**Warrenton Planning Commission**

TO: Warrenton Planning Commission  
FROM: Mark Barnes, Interim Planning Director  
RE: Osburn Plumbing Site Design Review (SDR20-04); Conditional Use (CUP20-01); and Variance (V20-01)

**PRELIMINARY GRADING AND LANDSCAPE PLAN**  
SCALE: 1" = 30'

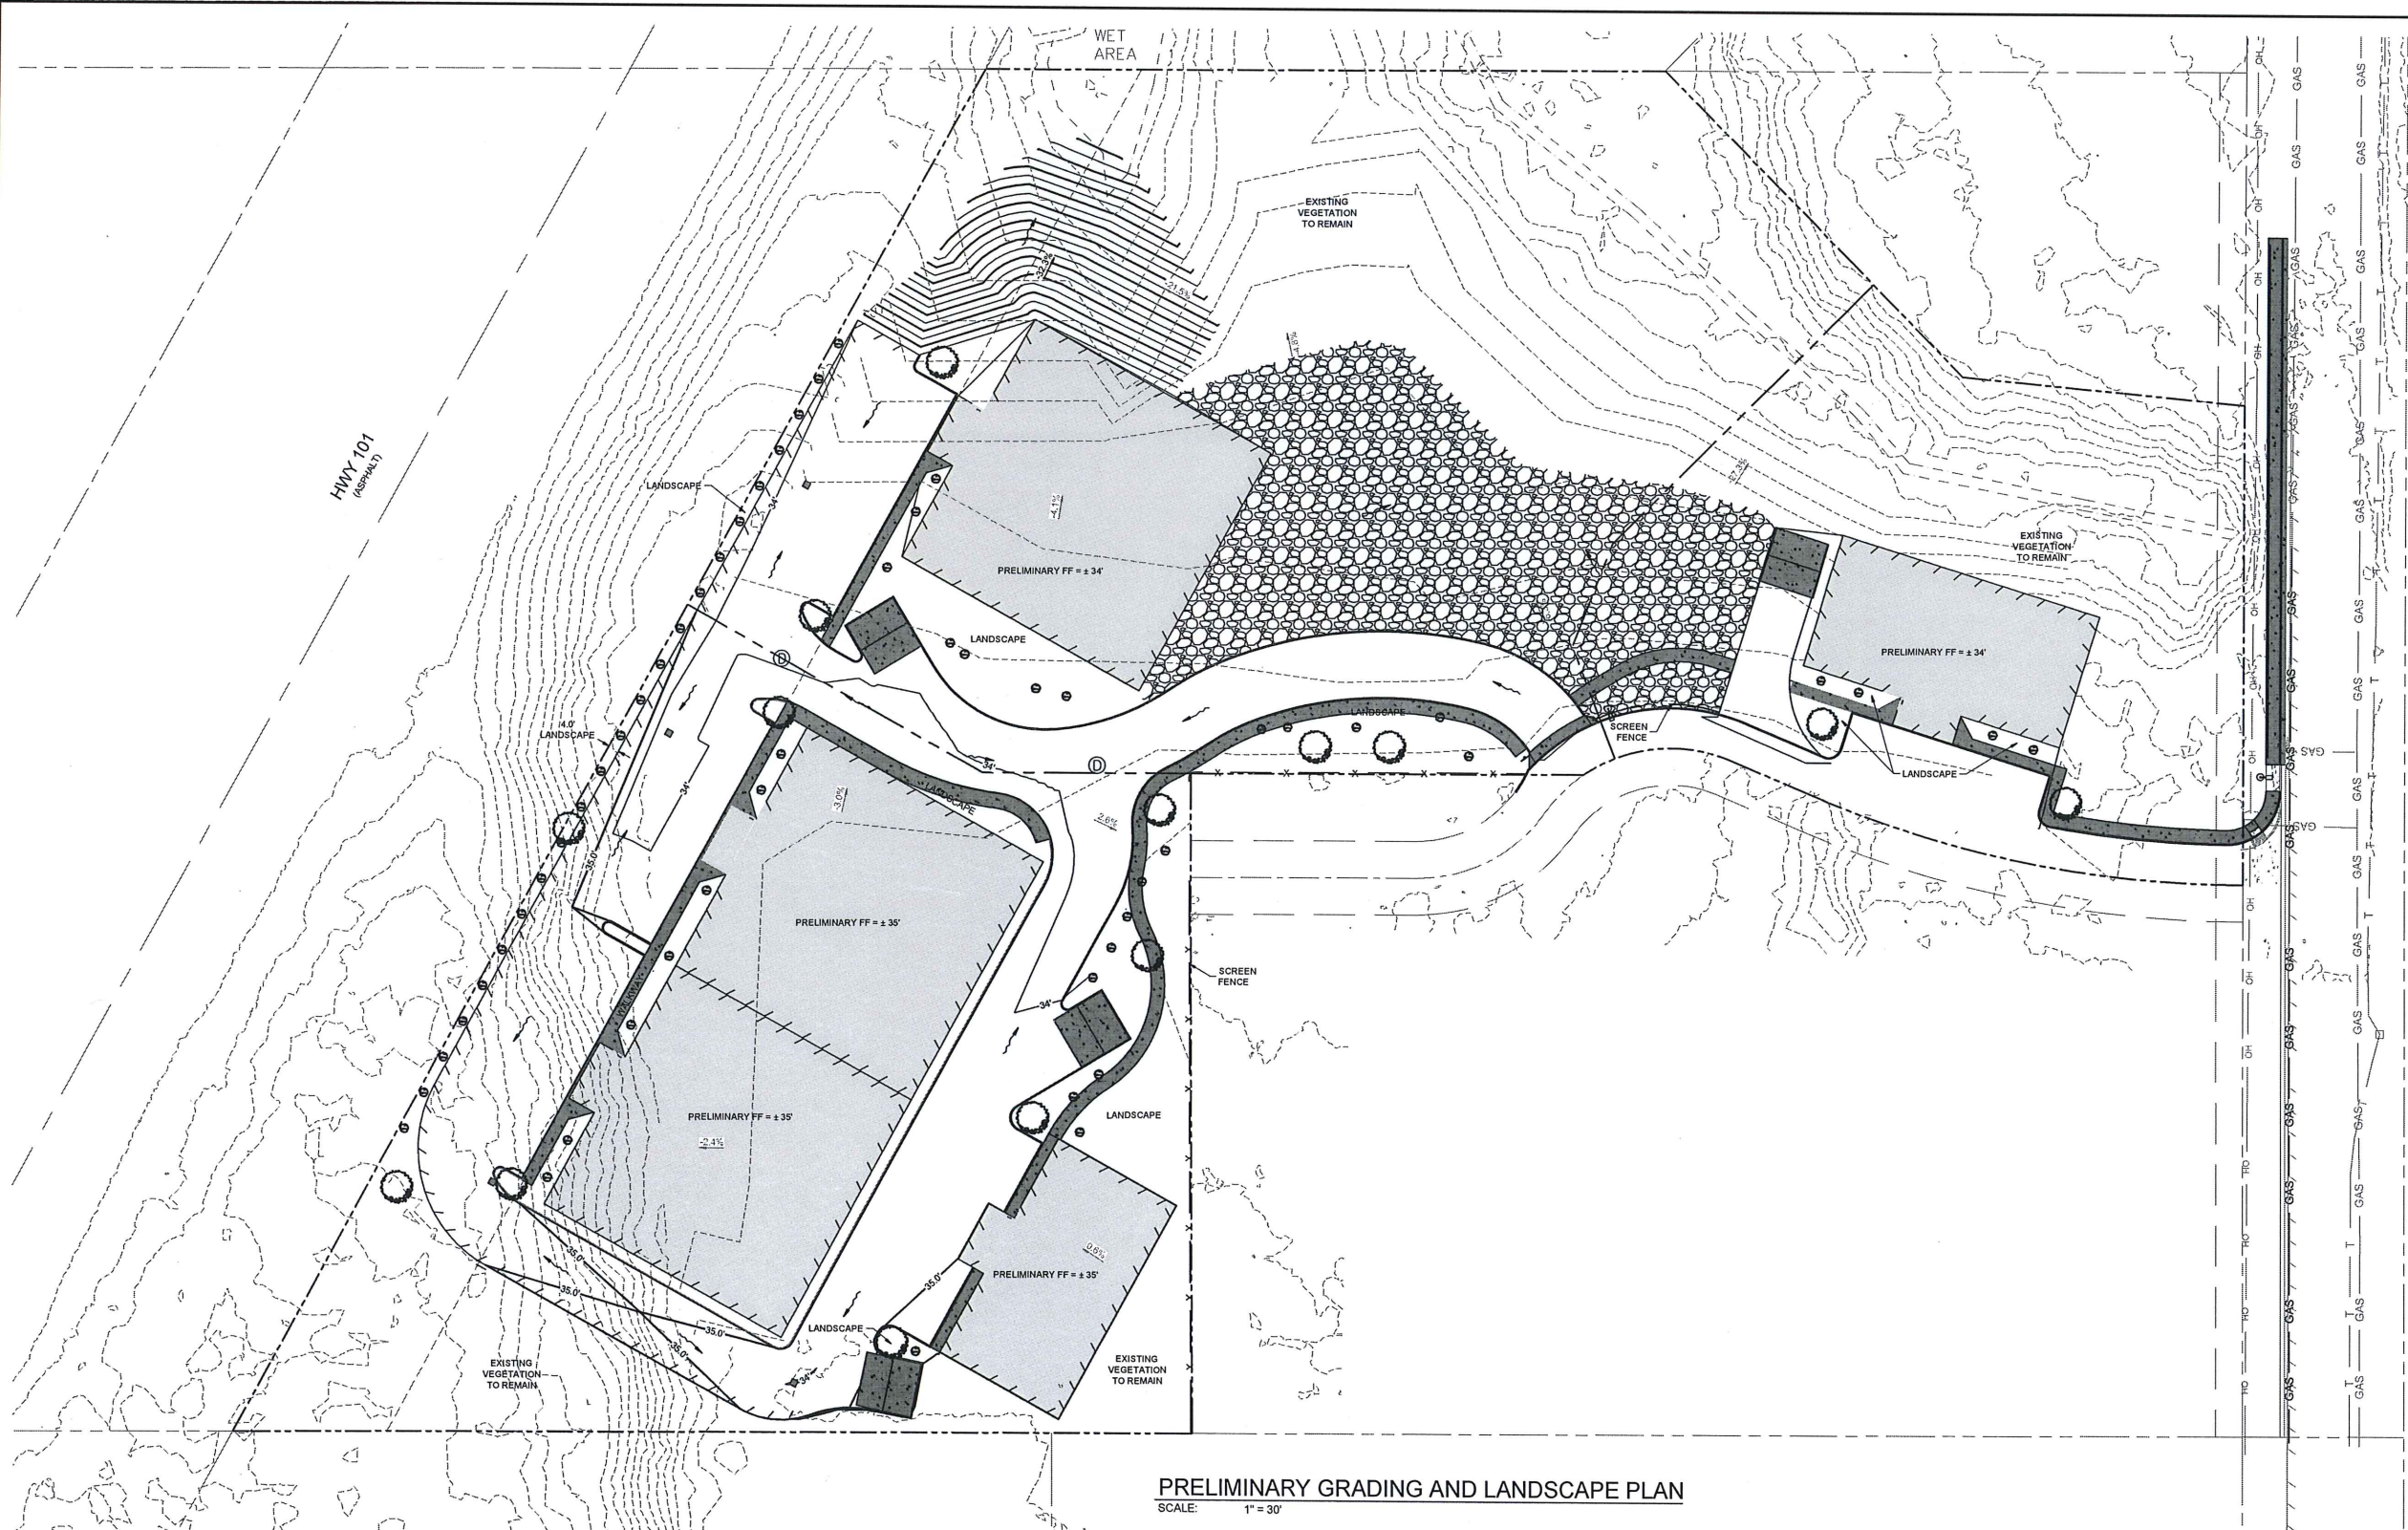
The site is generally level and dry. Site topography is shown on Sheet C4 of the applicant's site plan. A preliminary stormwater report was prepared at the applicant's expense and is included with the application materials. Paved and impervious areas will create additional drainage needs, but the applicant's engineer states that the proposed stormwater conveyance can accommodate these needs. The proposed type of construction can be supported by the site if a proper foundation can be designed. The adjoining Clatsop Memory Care facility is built on similar soils and site conditions without extraordinary measures. Based on this, the Planning Commission can find that the site's physical characteristics, in terms of topography, soils and other pertinent considerations, are appropriate for the use.

According to figures provided on sheet C4 of the applicant's site plan, the site covers about 194,567 square feet. Proposed new landscaping will cover about 12,922 square feet, or about 6.6 percent of the site. Conserved landscaping covers an additional 76,766 square feet, or about 39.5 percent. As proposed, new landscaped areas plus existing landscaping to be preserved cover about 46 percent of the site, thus meeting the coverage standard. These figures are broken-down by construction phase on Sheet C4 of the applicant's revised site plan.
